Construction Change Directive

PROJECT: *(name and address)*
Highland Township Fire Station 2
PIA #18-122B

CCD INFORMATION:
Directive Number: 001
Date: July 13, 2021

“EXHIBIT A” – CCD NO. 1

ITEM C1 TS-1 SITE TOPOGRAPHIC SURVEY

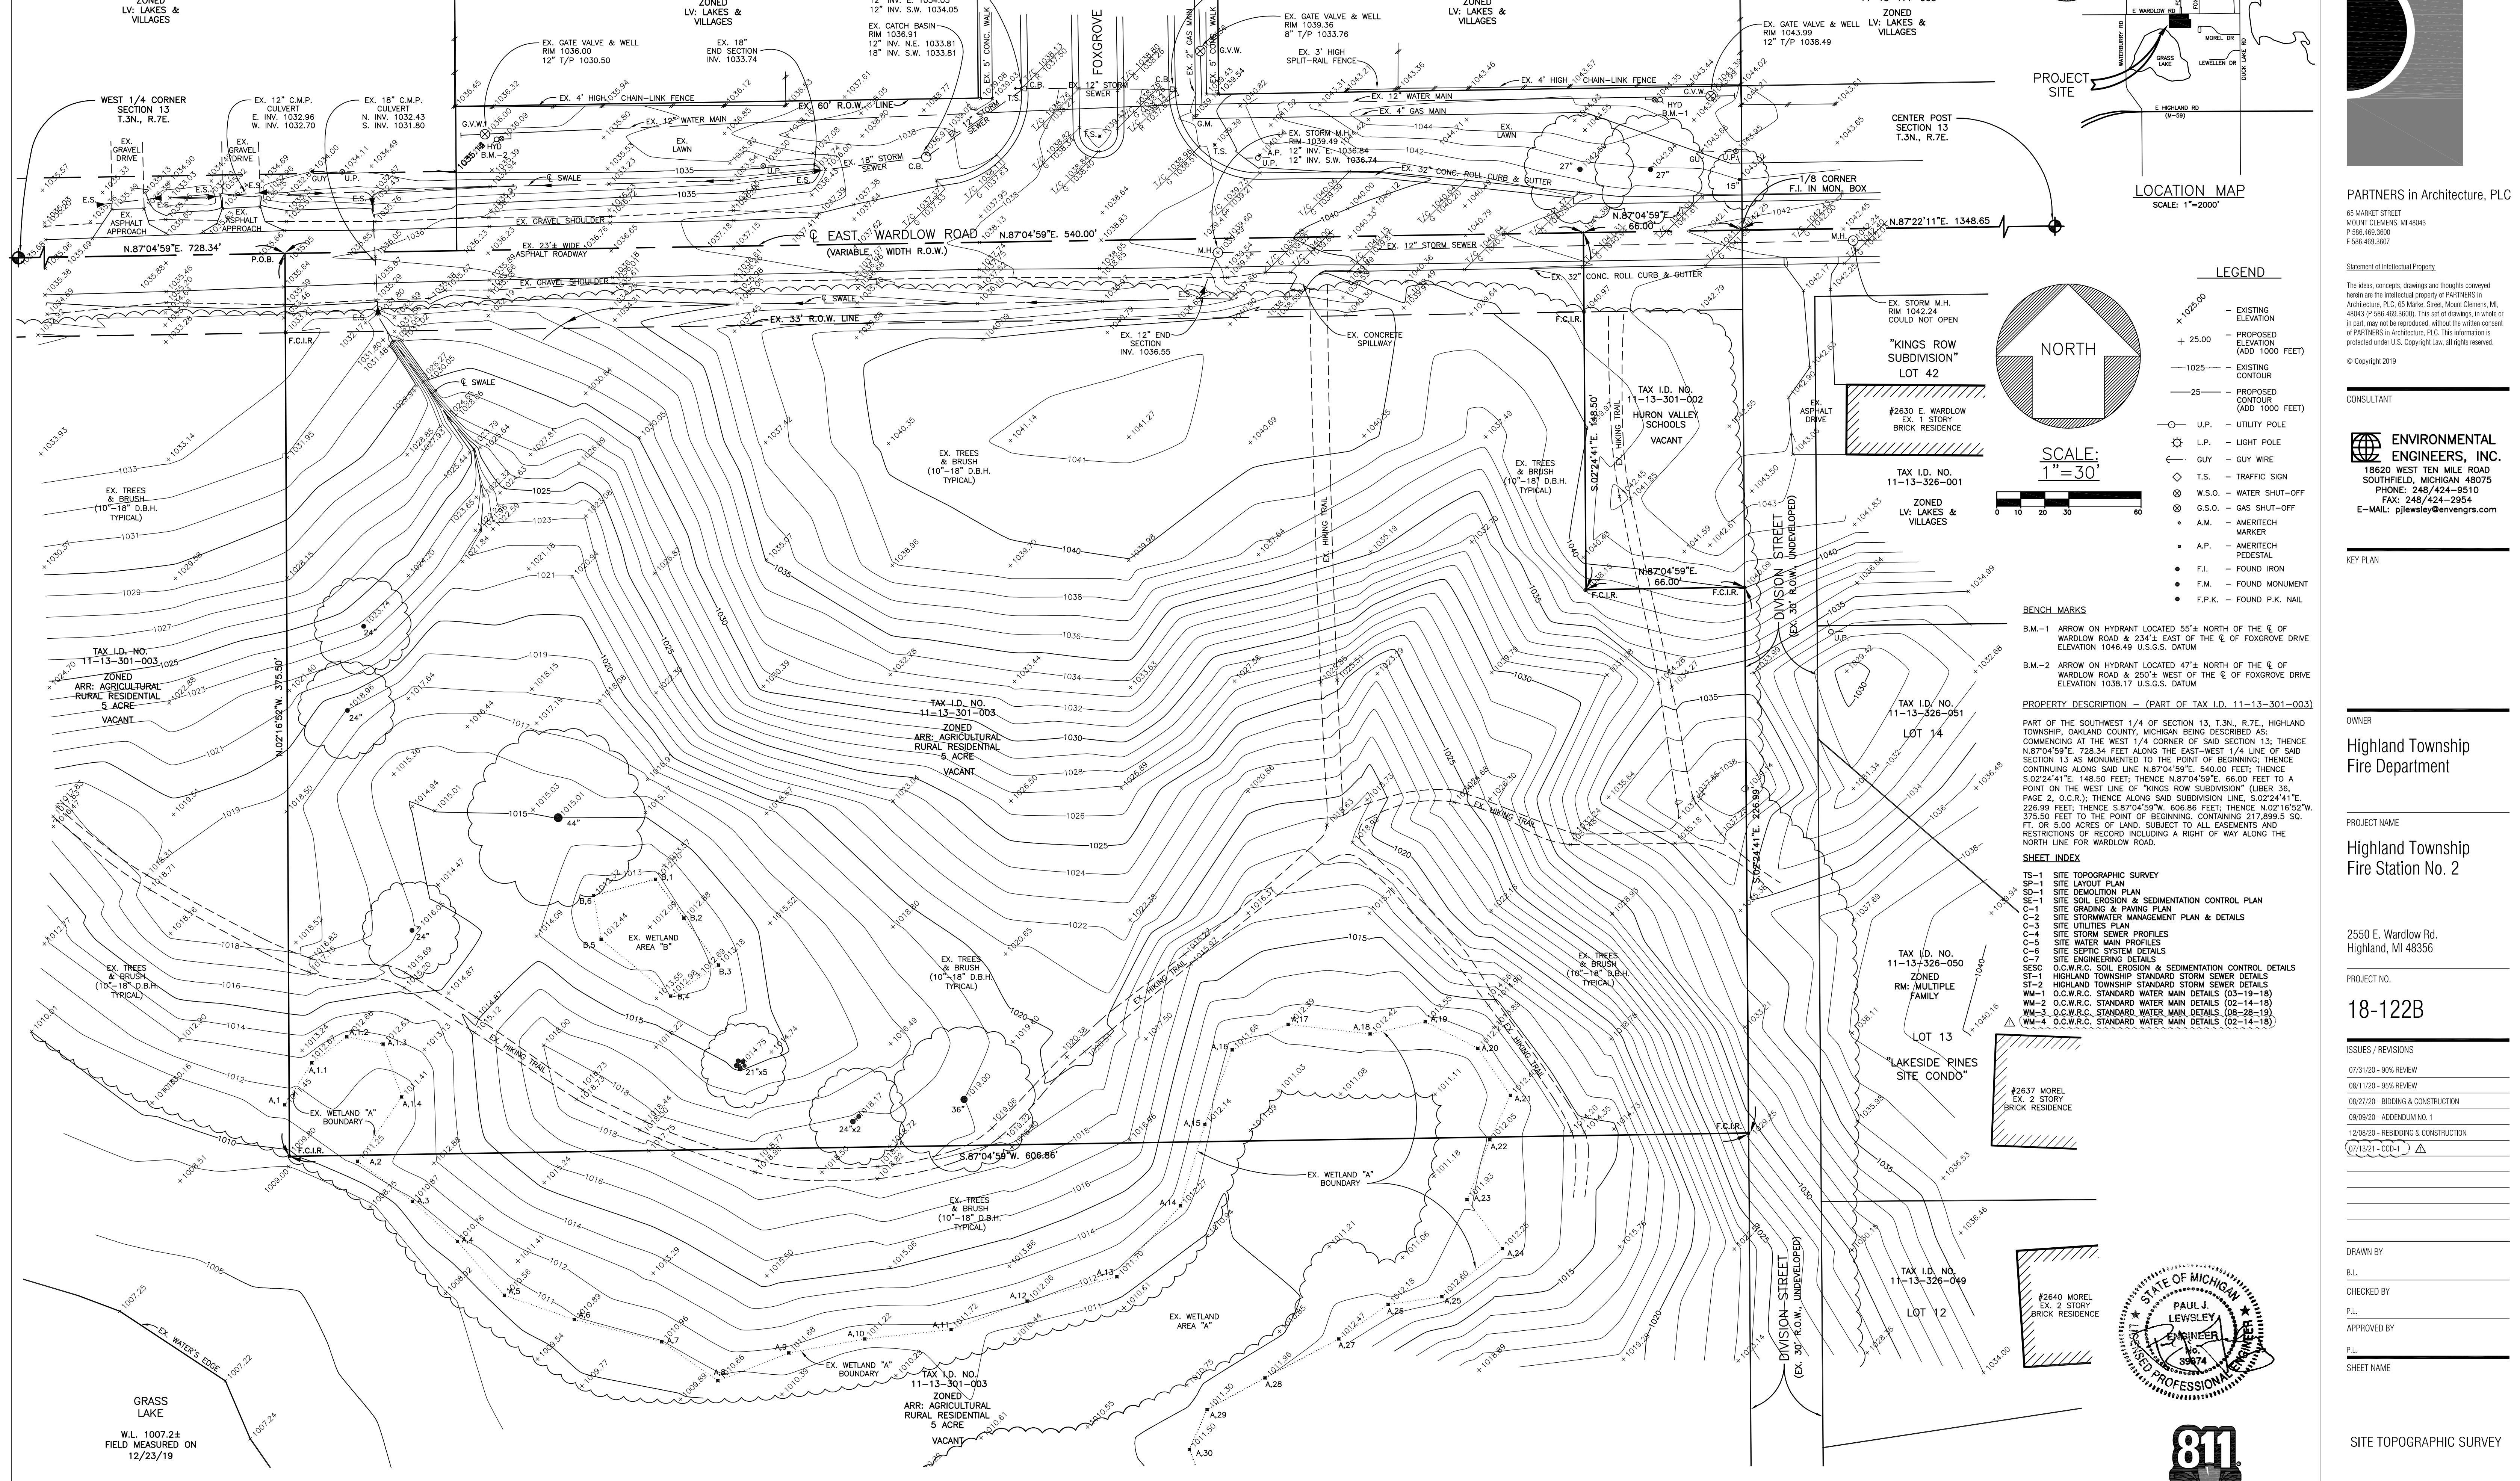
A. Added Sheet WM-4 O.C.W.R.C. Standard Water Main Details to sheet index.

ITEM C2 SP-1 SITE LAYOUT PLAN

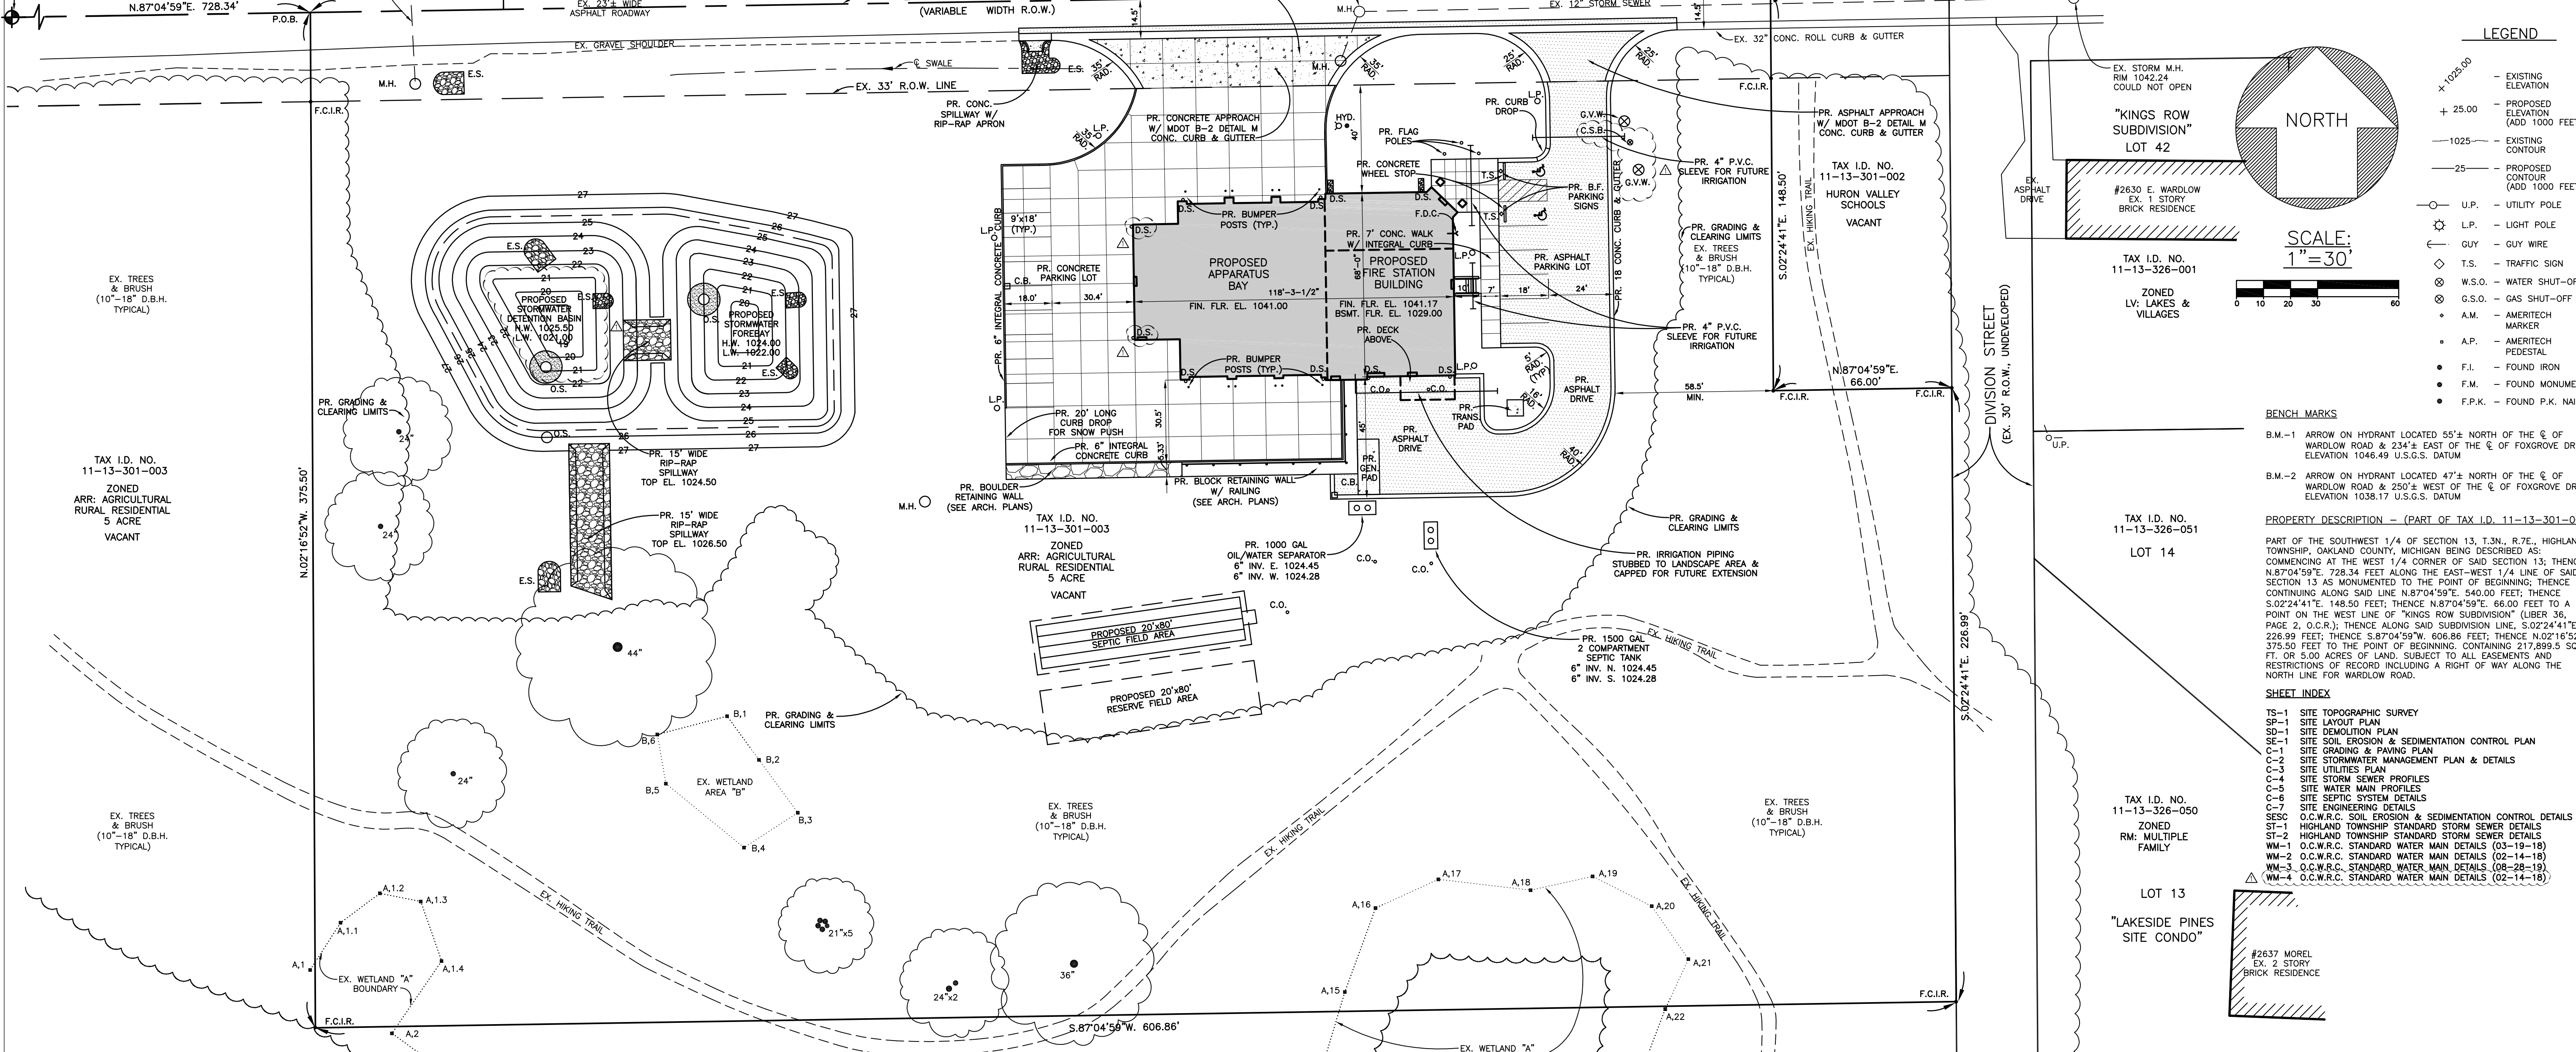
- A. Added Sheet WM-4 O.C.W.R.C. Standard Water Main Details to sheet index.
- B. Added 2' deep sediment sump in Stormwater Detention Basin.
- C. Replaced single center downspout pipe on building west end with ones at northwest & southwest building corners.
- D. Shifted fire line & water service valve locations as necessary to separate these lines just south of the hydrant lead tee.

ITEM C3 SE-1 SITE SOIL EROSION & SEDIMENTATION CONTROL PLAN

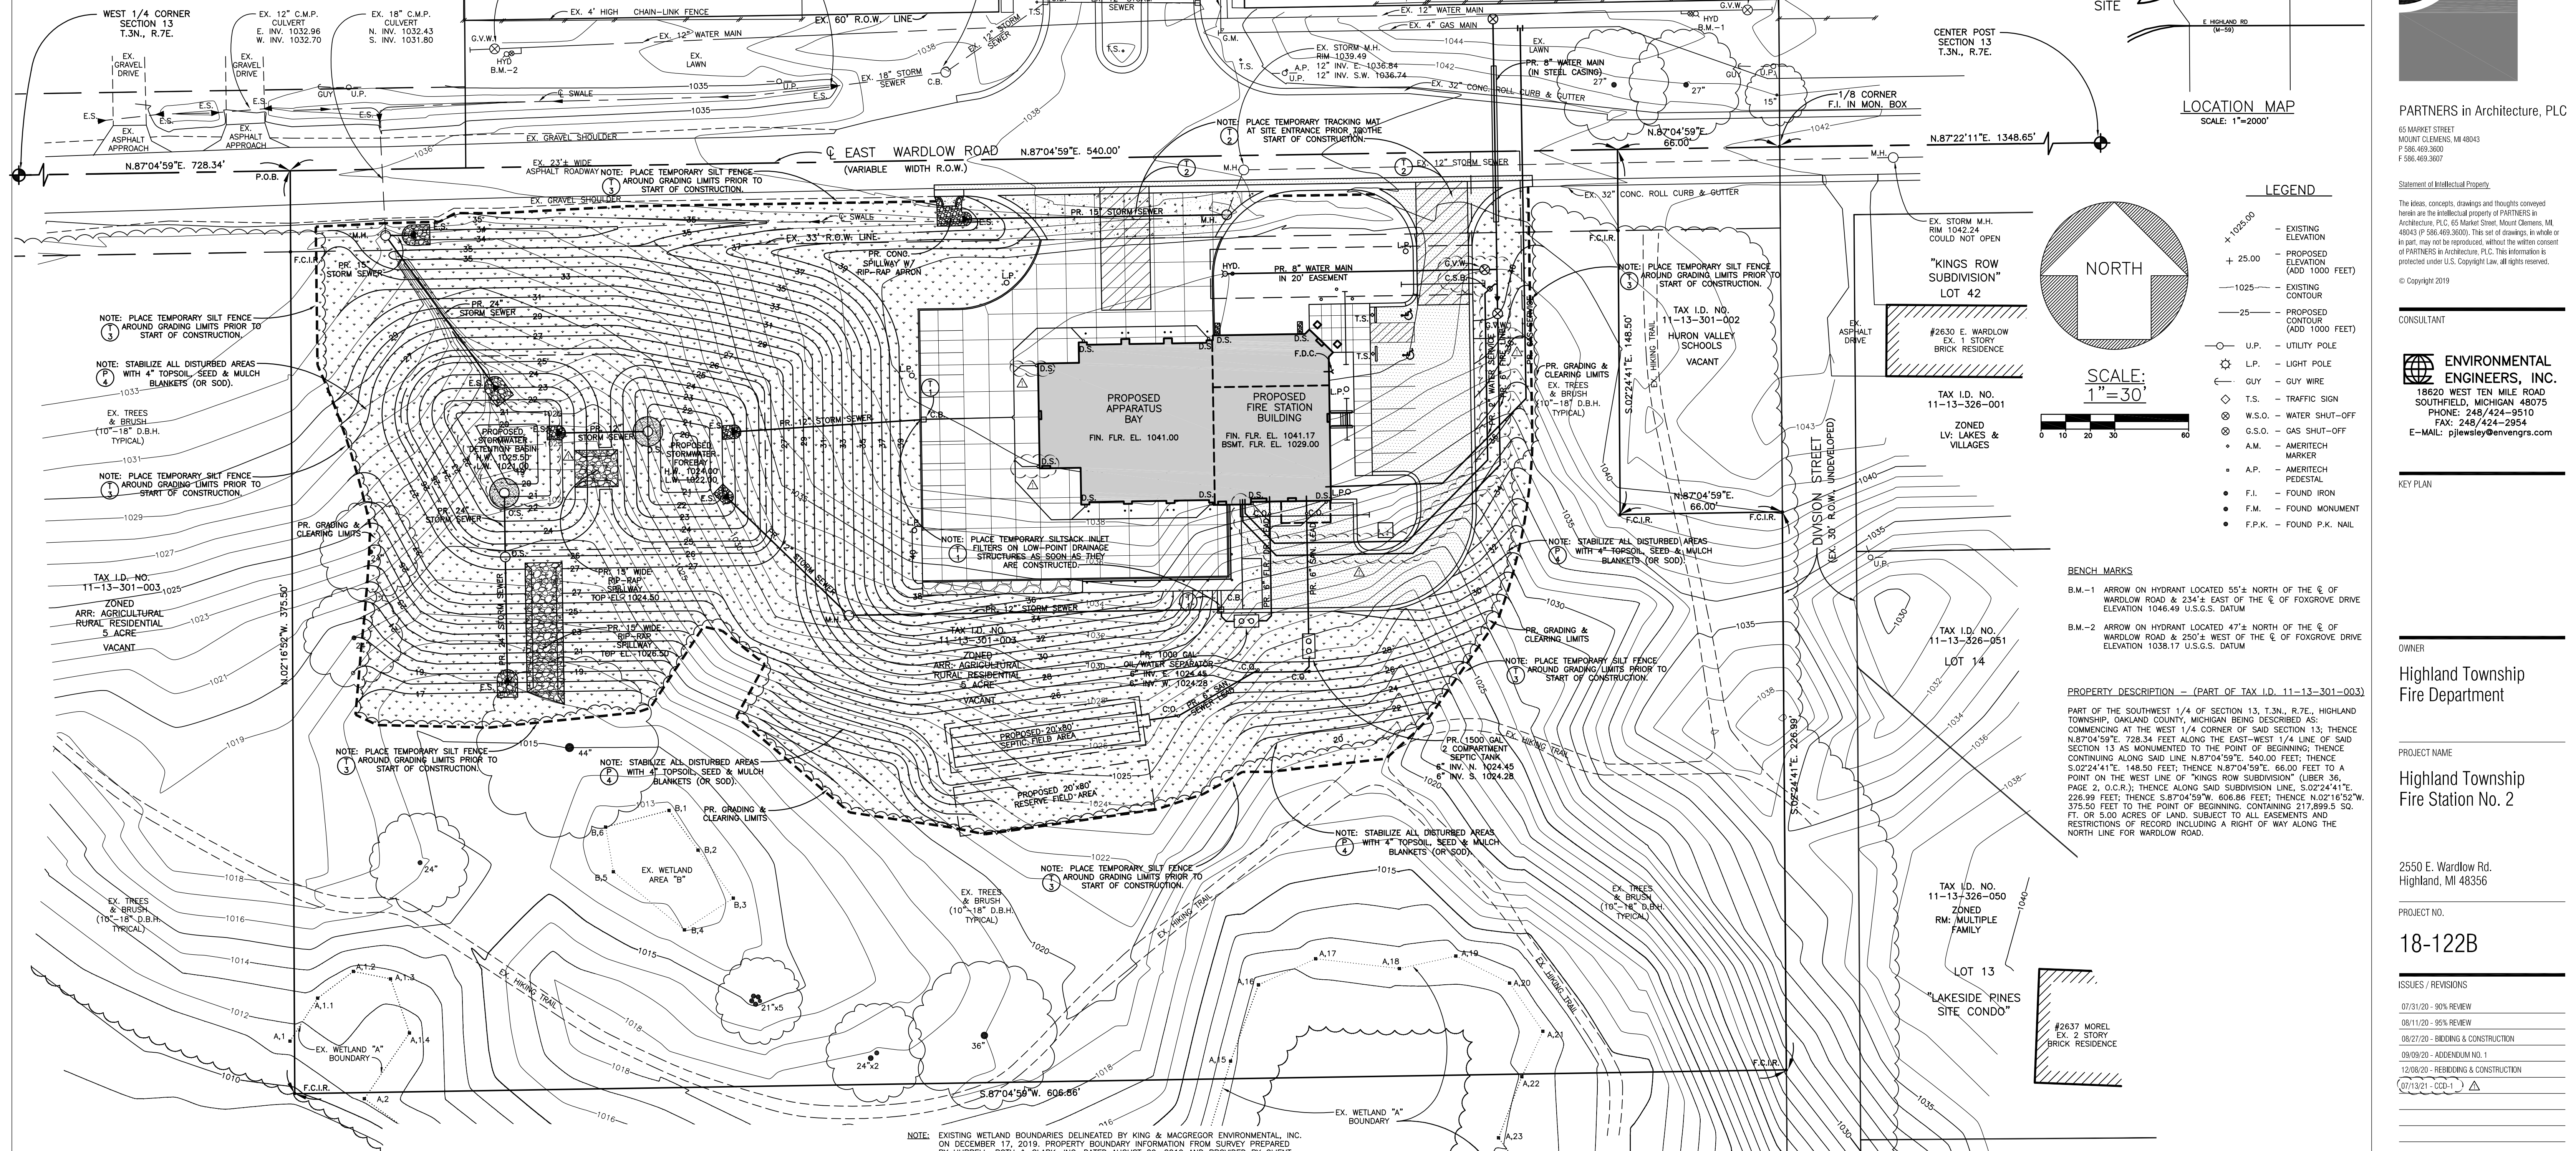
- A. Added 2' deep sediment sump in Stormwater Detention Basin.
- B. Replaced single center downspout pipe on building west end with ones at northwest & southwest building corners.

- C. Replaced single 8" water lead south of hydrant lead tee with separate 2" water service and 6" fire line.
